REPORT OF ALTERATIONS TO DESIGNATED RESOURCE
Site Number/Address: 1112 Mathews St.
Laurel School National Register Historic District
ISSUED: 9/1/2023

The alterations include: Addition of 131 square-feet to include a new primary bathroom and closet; also raising the roofline for kitchen.

NEW ADDITION AT
1112 MATTHEWS ST.
FORT COLLINS, CO

ELEVATIONS

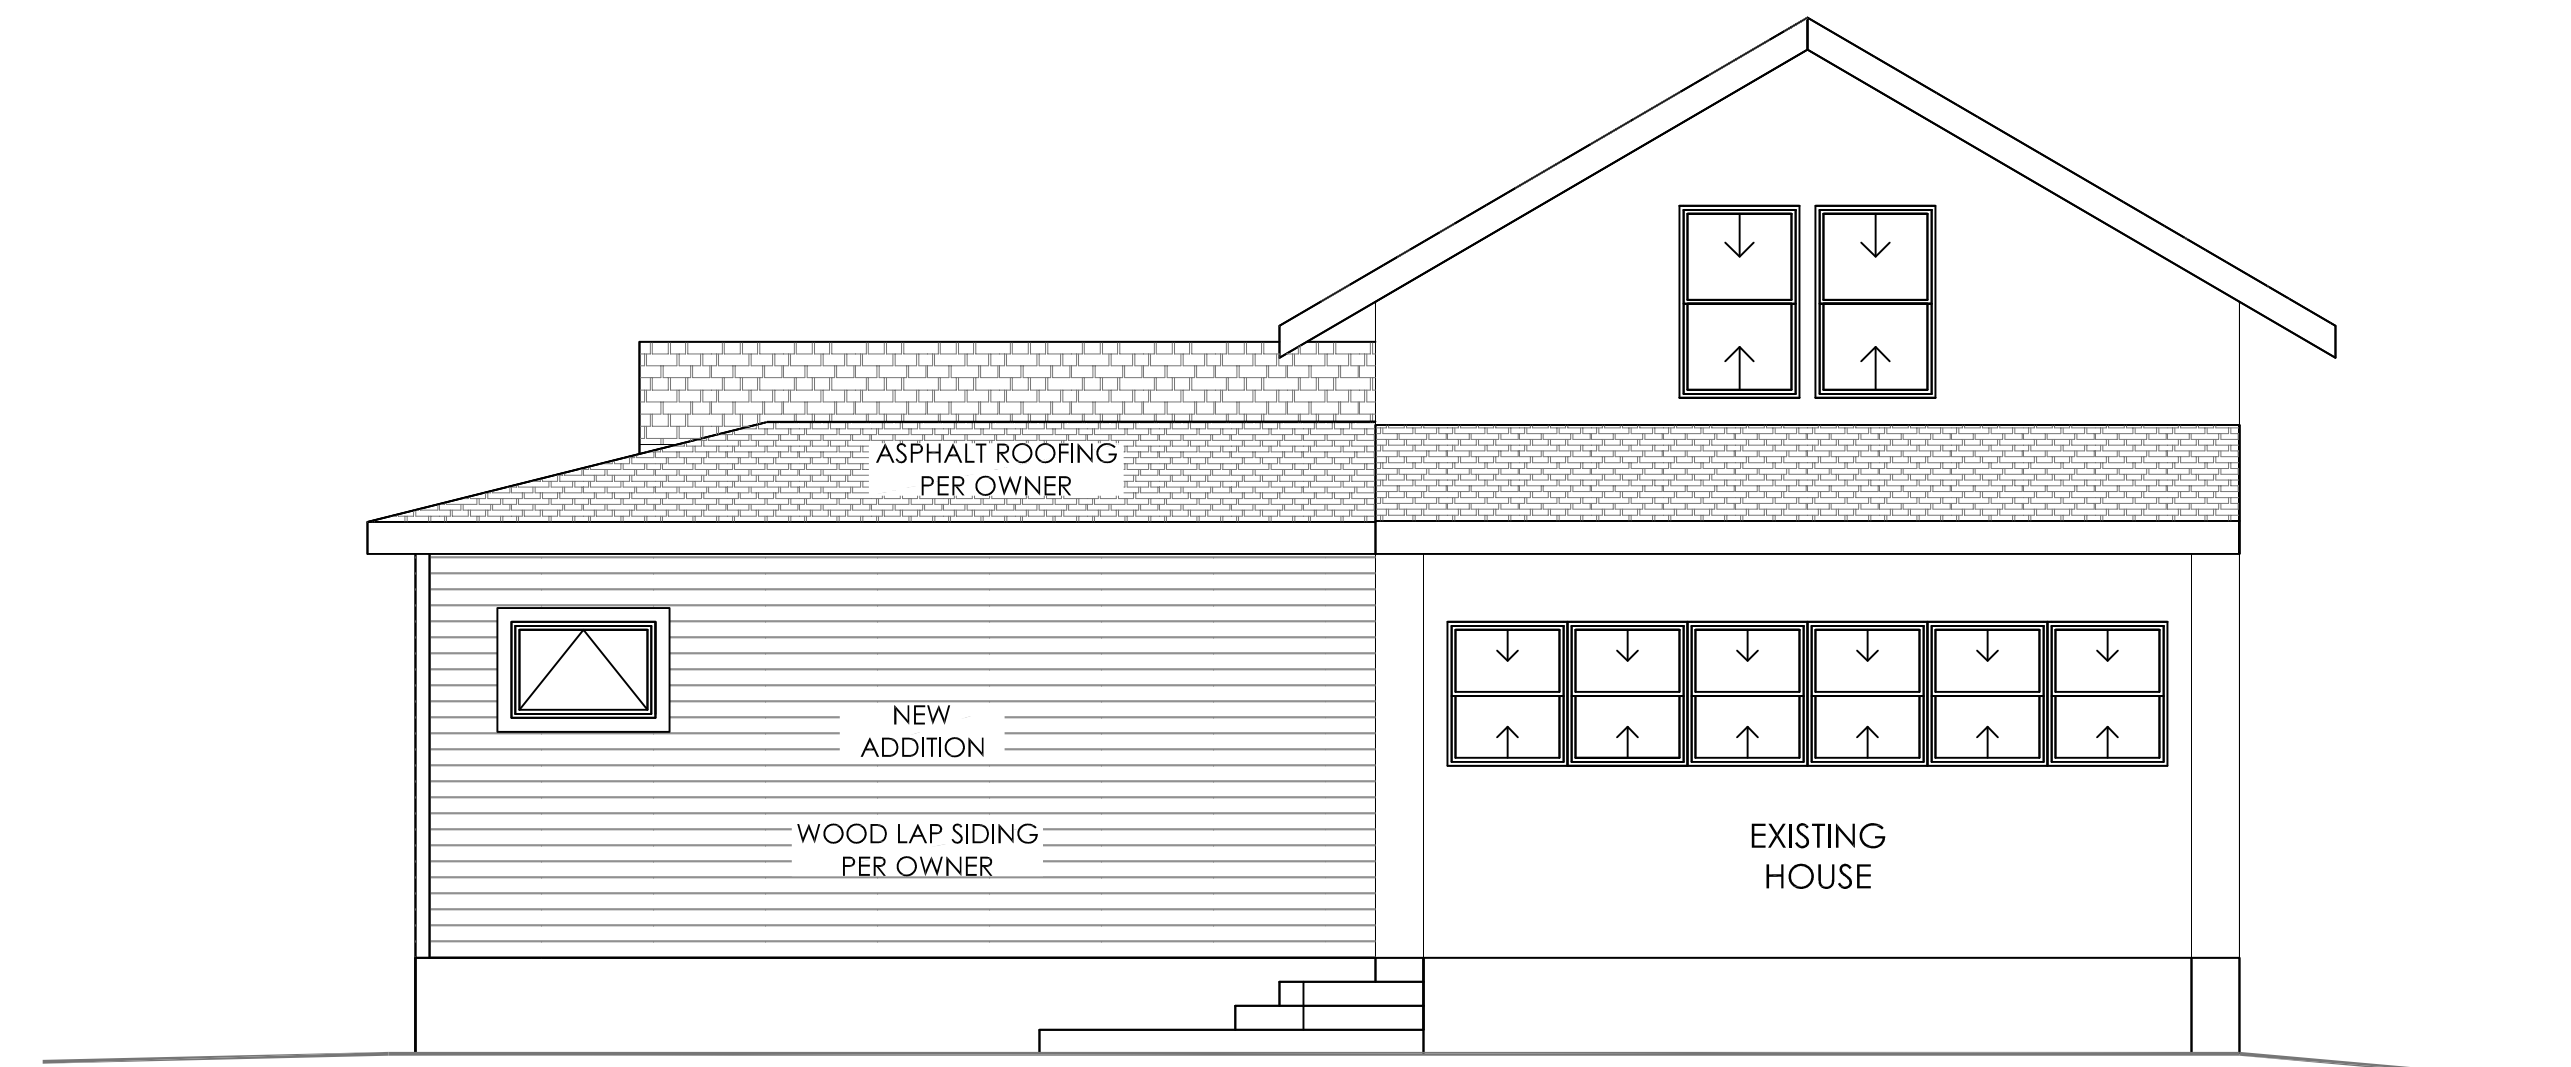
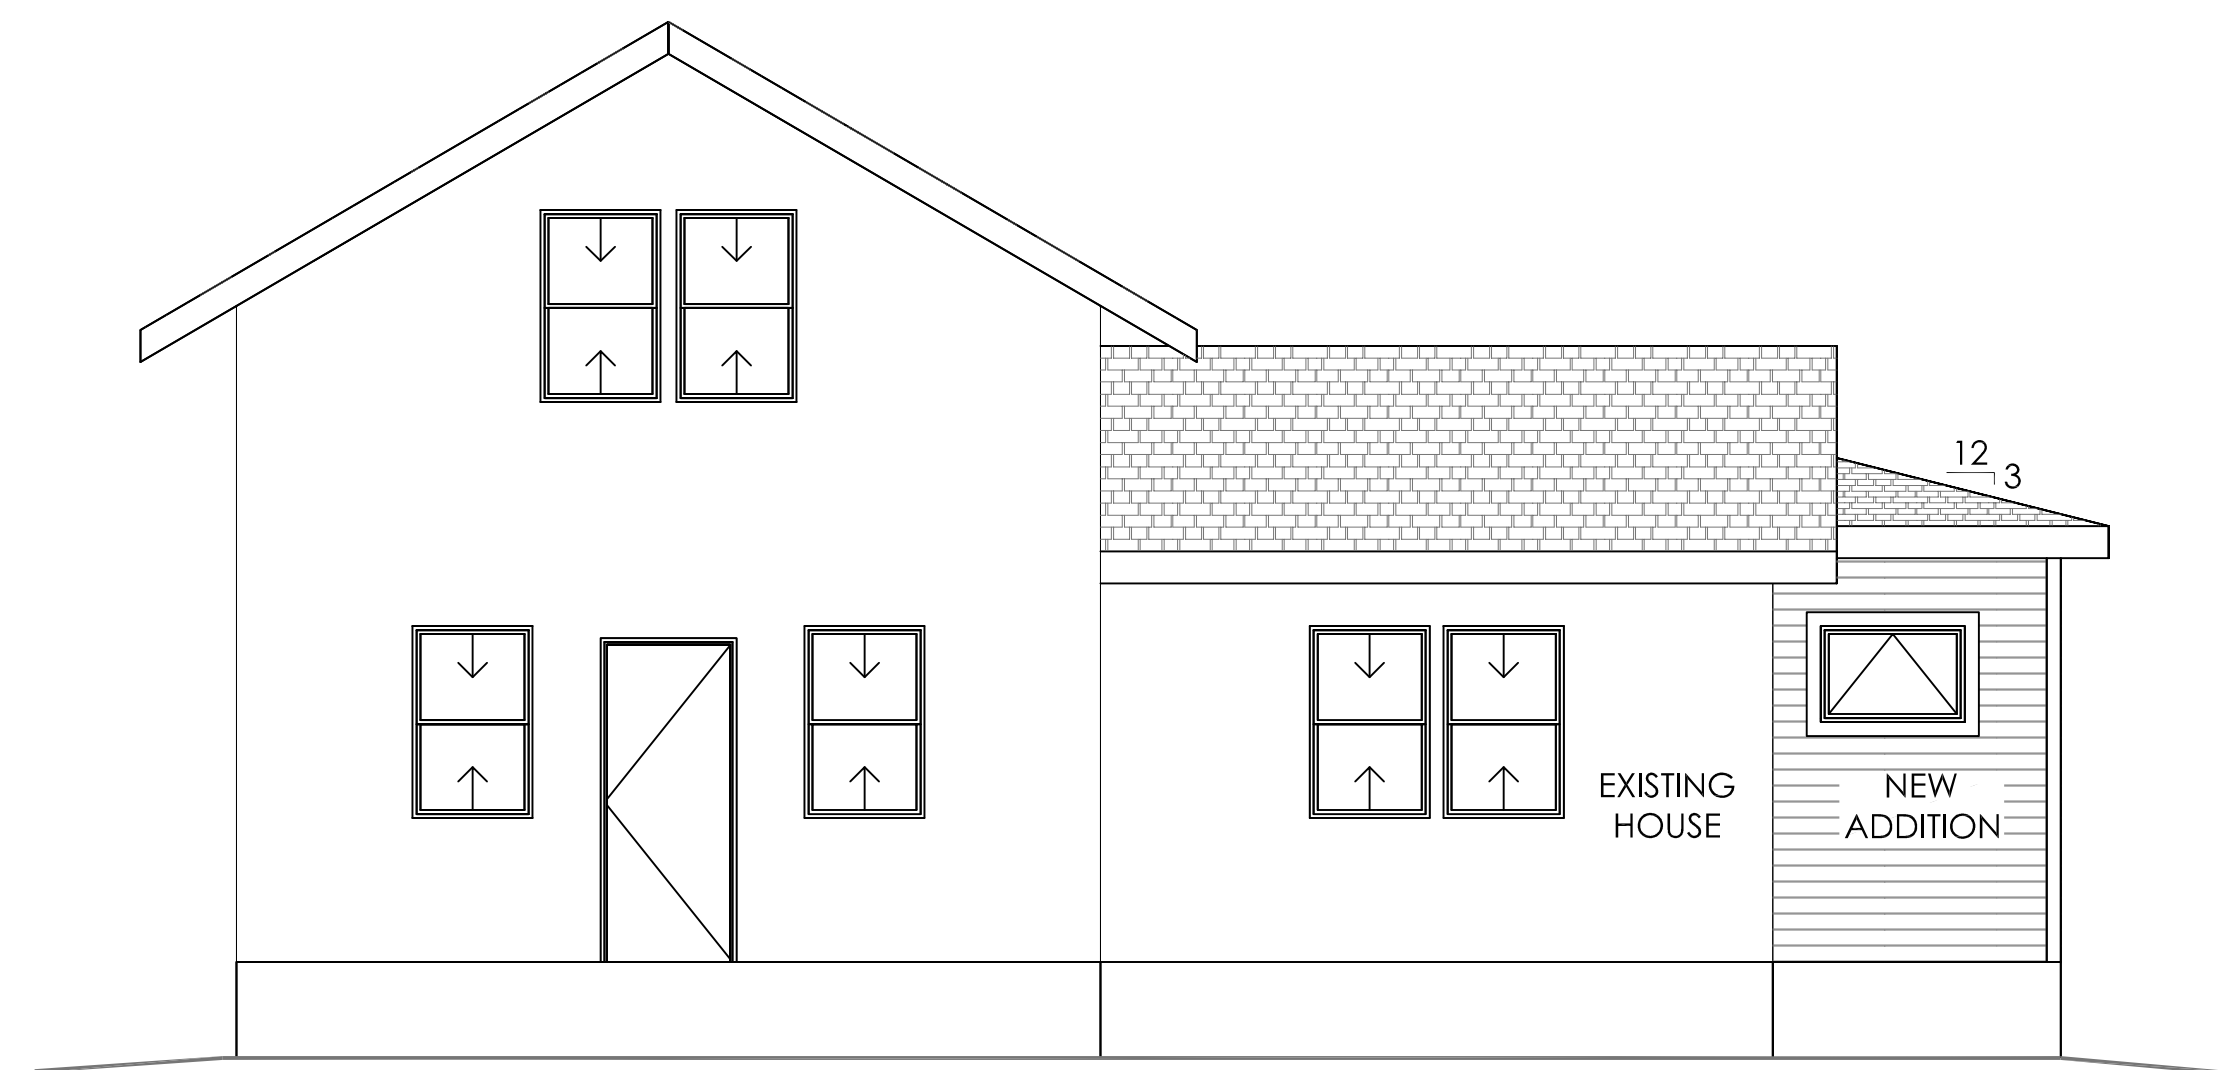
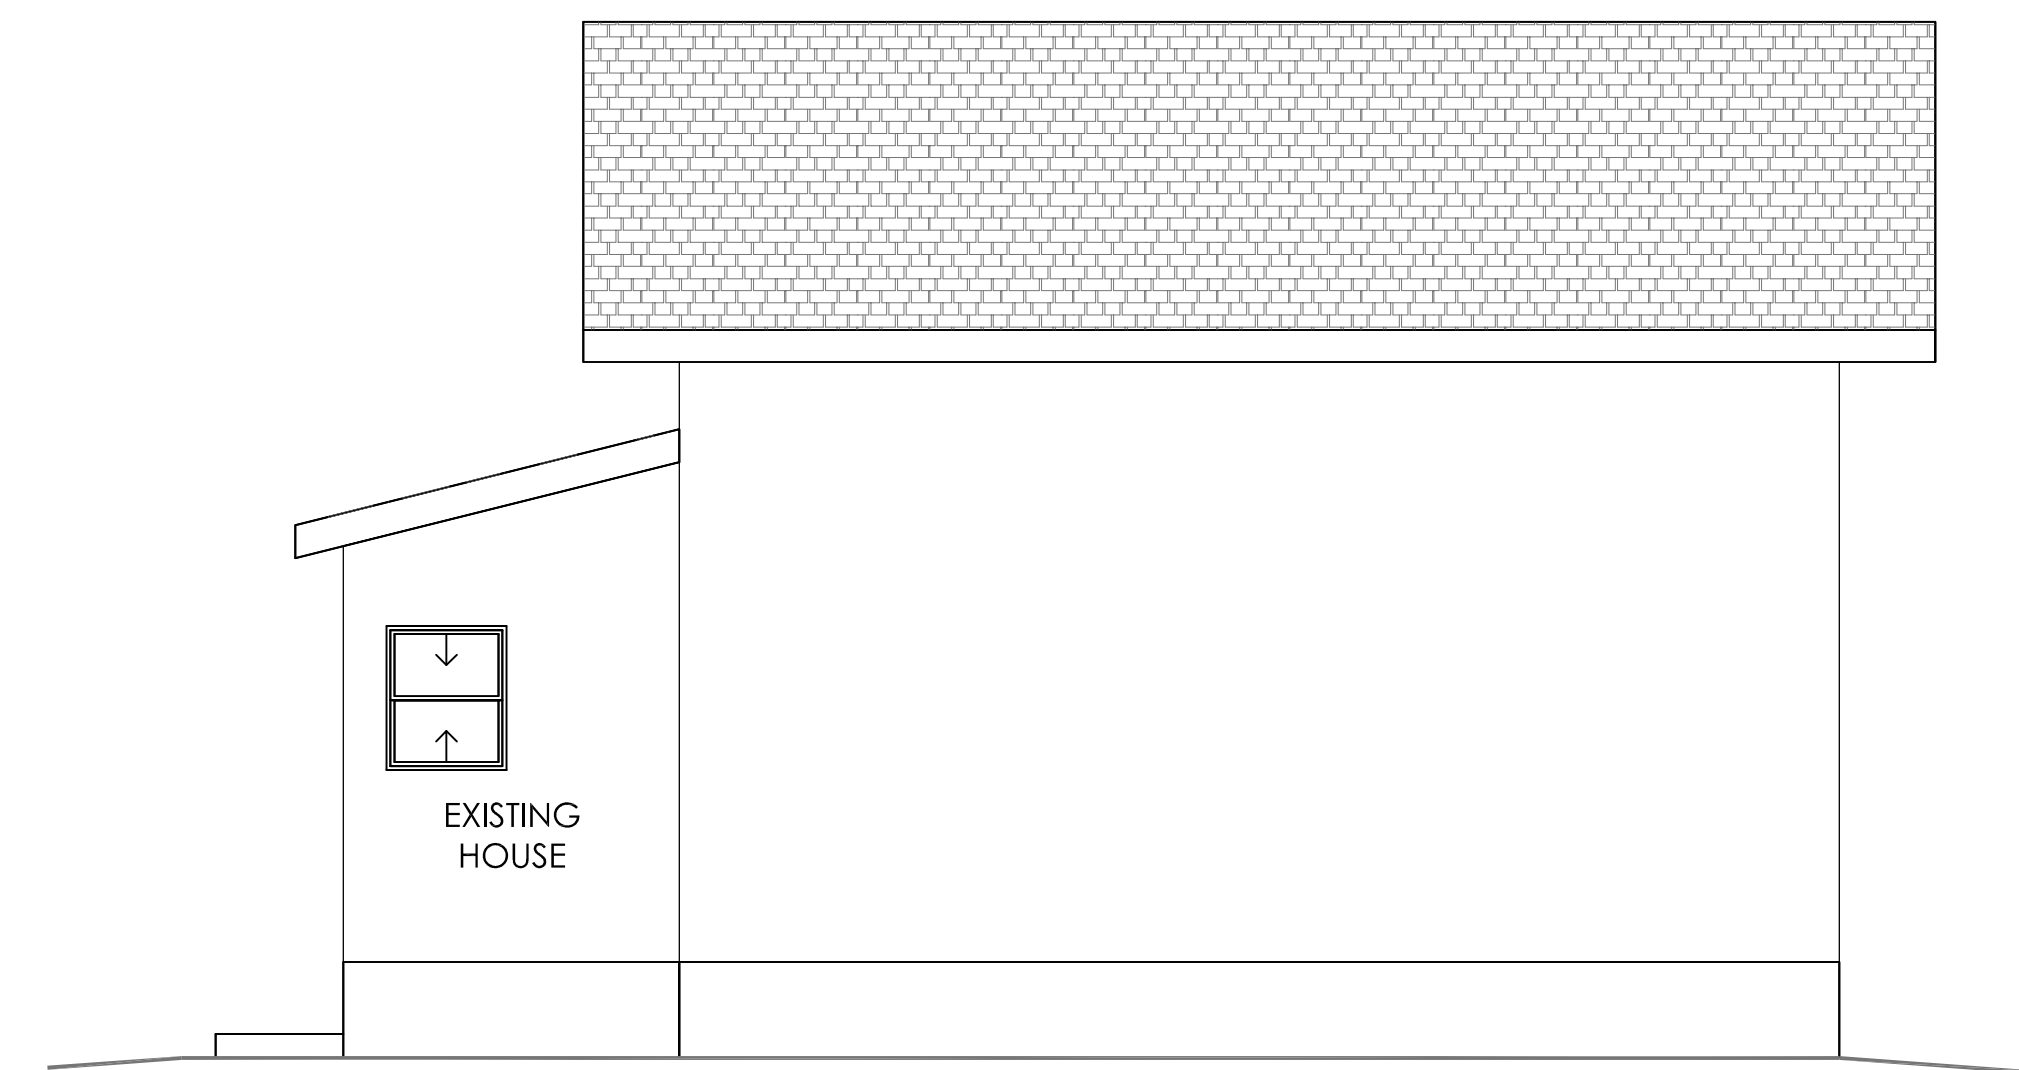
<p>SOI #2</p>	<p><i>The historic character of a property will be retained and preserved. The removal of distinctive materials or alteration of features, spaces, and spatial relationships that characterize a property will be avoided.</i></p> <p>This project will remove some distinctive materials/features from the existing house; specifically, two existing windows will be filled in to accommodate the new internal configuration of the house. Although these features are on the rear of the house, the house’s location on an alley/right-of-way make their removal more significant.</p>	<p>N</p>
<p>SOI #3</p>	<p><i>Each property will be recognized as a physical record of its time, place, and use. Changes that create a false sense of historical development, such as adding conjectural features or elements from other historic properties, will not be undertaken.</i></p>	<p>N/A</p>
<p>SOI #4</p>	<p><i>Changes to a property that have acquired historic significance in their own right will be retained and preserved.</i></p>	<p>N/A</p>

<p>SOI #5</p>	<p><i>Distinctive materials, features, finishes, and construction techniques or examples of craftsmanship that characterize a property will be preserved.</i></p> <p>Again, the removal of historic window material does not meet this standard.</p>	<p>N</p>
<p>SOI #6</p>	<p><i>Deteriorated historic features will be repaired rather than replaced. Where the severity of deterioration requires replacement of a distinctive feature, the new feature will match the old in design, color, texture, and, where possible, materials. Replacement of missing features will be substantiated by documentary and physical evidence.</i></p>	<p>N/A</p>
<p>SOI #7</p>	<p><i>Chemical or physical treatments, if appropriate, will be undertaken using the gentlest means possible. Treatments that cause damage to historic materials will not be used.</i></p>	<p>N/A</p>
<p>SOI #8</p>	<p><i>Archeological resources will be protected and preserved in place. If such resources must be disturbed, mitigation measures will be undertaken.</i></p> <p>It is unlikely that archaeological resources will be uncovered during the work for this project, but the owner/applicant is advised that should any such materials be discovered during the excavation needed for this project, please protect those resources in place and contact the Historic Preservation office for assistance.</p>	<p>Y</p>

<p>SOI #9</p>	<p><i>New additions, exterior alterations, or related new construction shall not destroy historic materials that characterize the property. The new work shall be differentiated from the old and shall be compatible with the massing, size, scale, and architectural features to protect the historic integrity of the property and its environment.</i></p> <p>The raising of the roof for the kitchen portion of the house does not substantially impact the character of the historic property.</p> <p>Although the proposed roof form of the addition and the proposed window types effectively differentiate the addition from the historic house, certain aspects of the design do not meet this standard. The proposed window material, vinyl, is not compatible with a house of this age. Additionally, although the addition is relatively small, its visibility from the house’s primary elevation does not meet this standard.</p>	<p>N</p>
